# Arcos Executive Center

## Planning and Zoning

March 20<sup>th</sup>, 2018

# PIM COMMENTS FROM JUNE 1, 2017

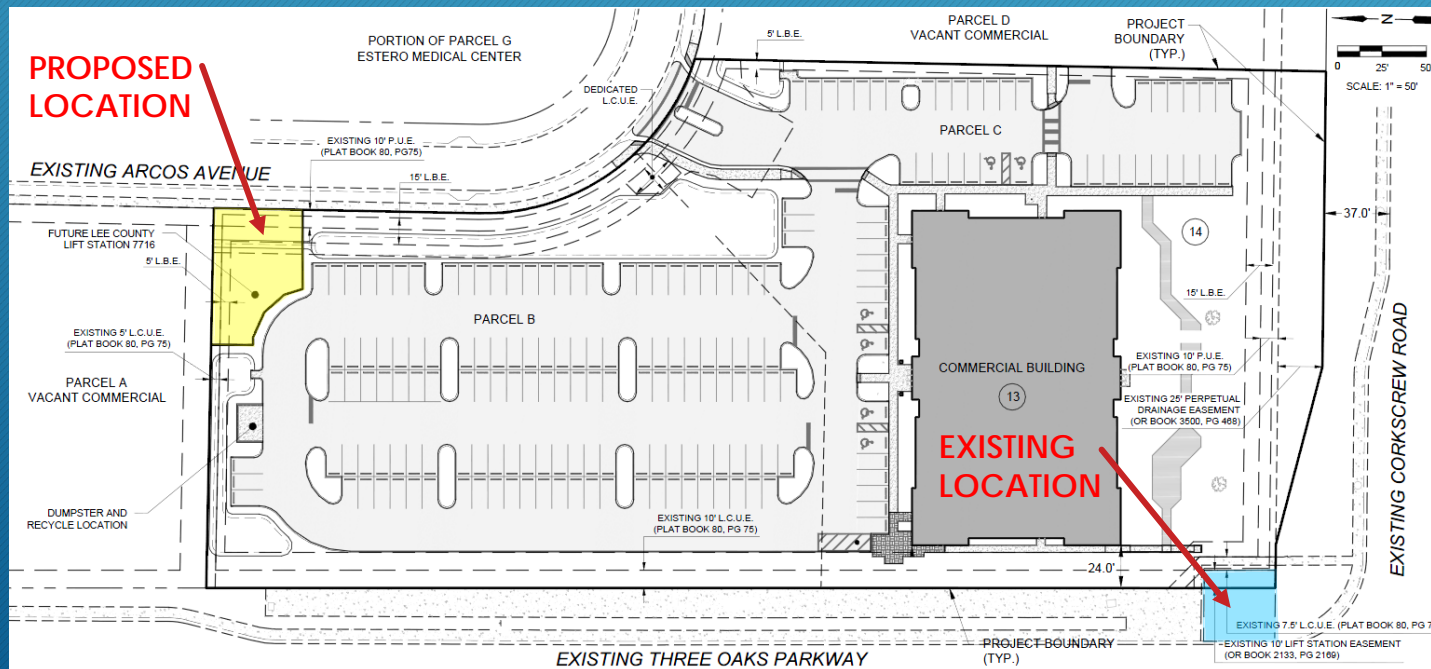
## 2. Will relocating the lift station to its proposed location affect the oak trees due to the deep trenching and construction?

Per my conversation with LCU no deep trenches are proposed along Three Oaks Parkway.

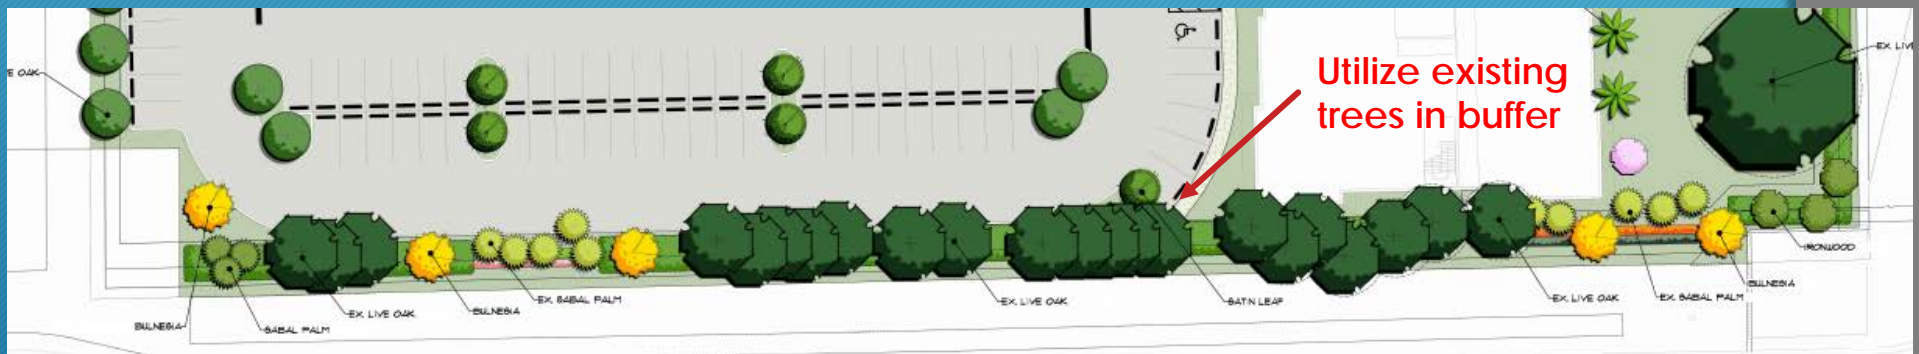
3. The portion of the building along Three Oaks Parkway is in close proximity to the existing oak trees. Will construction of the building potentially harm those trees?

Originally we were trying to save the existing trees and plant material in the berm along Three Oaks Parkway, however due to the proximity of the building and parking lot we are now proposing new landscape material along the entire berm.
